Our ref: HC05441B

31 March 2022

**Letter of objection to applications ref. 2021/4408/P and 2022/4408/L  
30 Percy Street, London, W1T 2DB**

Figure 1 - Extract from proposed plan of rear first-floor terrace approved in 2019 – Walkable outdoor terrace on the upper left-hand corner, glazed surface to the right. [REDACTED] Percy Street is further right.

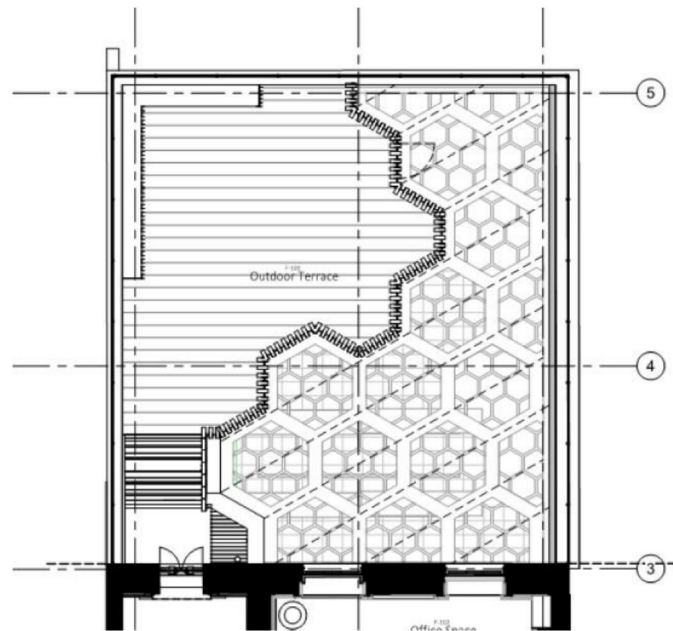
The image below, extracted from your delegated report of the 2019 applications, shows the extent of the proposed - and approved - rear terrace. The hexagonal pattern to the right would have been glazed and accessible for maintenance purposes only. [REDACTED] to the right of the glazed area.

It is evident that the design was predicated on the need to clearly separate the new terrace, both physically and in terms of usage, from the boundary shared with [REDACTED] Percy Street. The combined effect of the glazed “gap” between the terrace and the adjoining property, the balustrade and privacy screen, and the boundary treatment along the party wall, would have prevented overlooking, and mitigated noise impacts.

Figure 2 - Current proposal

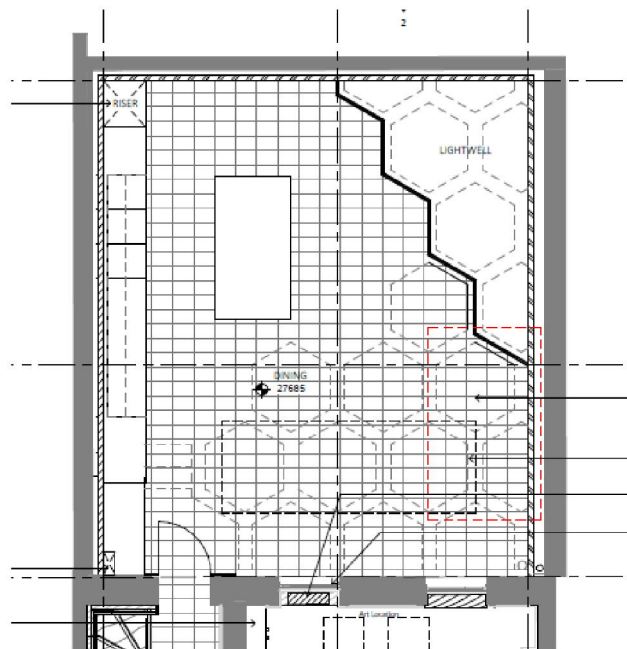
As shown in the extract below, the terrace now pursued is almost double in size than the one approved in 2019, it occupies the full width of the plot in the vicinity of the building, will not have any separation from 29 Percy Street for a length of 3.5 metres along the boundary. Effectively, all the mechanisms to prevent negative impacts on the amenity of 29 Percy Street have been removed, without any sound planning reason to do so.

At a single stroke, the design proposed by the current application has almost doubled the size of the terrace, removed the separation from the windows of [REDACTED], and made the eastern area usable and walkable.

The proposed terrace is very large and will be able to host crowded events in connection with the business use of 30 Percy Street. The terrace will create unneighbourly impacts on the adjoining properties, and [REDACTED] Percy Street in particular. There will be an increase sense of overlooking, noise in close proximity to the boundary, and an increased security risk.
